TO: Members of the MAG Standard Specifications and Details Committee

SUBJECT: MEETING NOTIFICATION AND TRANSMITTAL OF TENTATIVE AGENDA

MAG Standard Specifications and Details Committee
TENTATIVE AGENDA
March 4, 2015

Subject: Revisions to Sections 336, 321.10.3, 601.2.7 and Detail 200-1

DETAIL NO.
2200

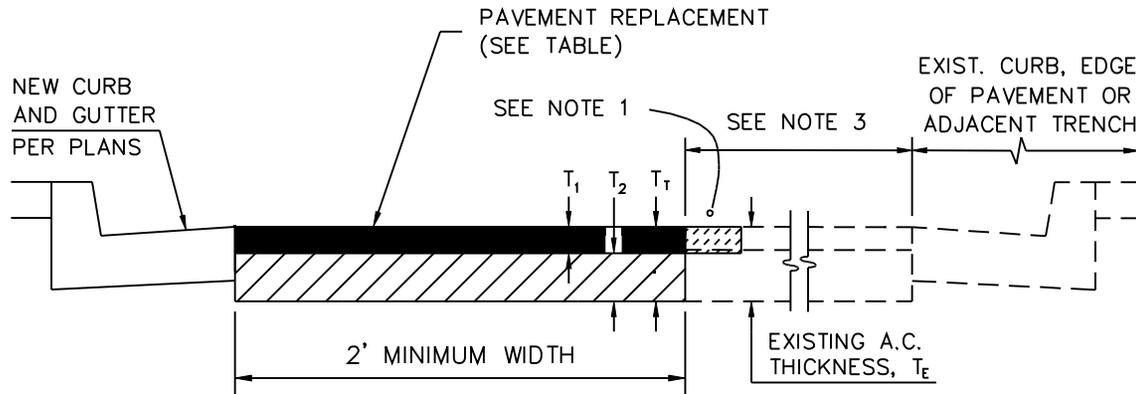
Comment [RTH2]: The asphalt match point shown in Detail 200-1 Type A Trench Repair and the Remnant Pavement Removal detail need to be revised to comply with this paragraph. See Scottsdale Detail 2200 for a suggested staggered joint modification.

Comment [RTH3]: Modify to require staged removal of asphalt pavement for trenches similar to Scottsdale Detail 2200, this provides for re-compaction of the non-confined base course adjacent to the open trench.
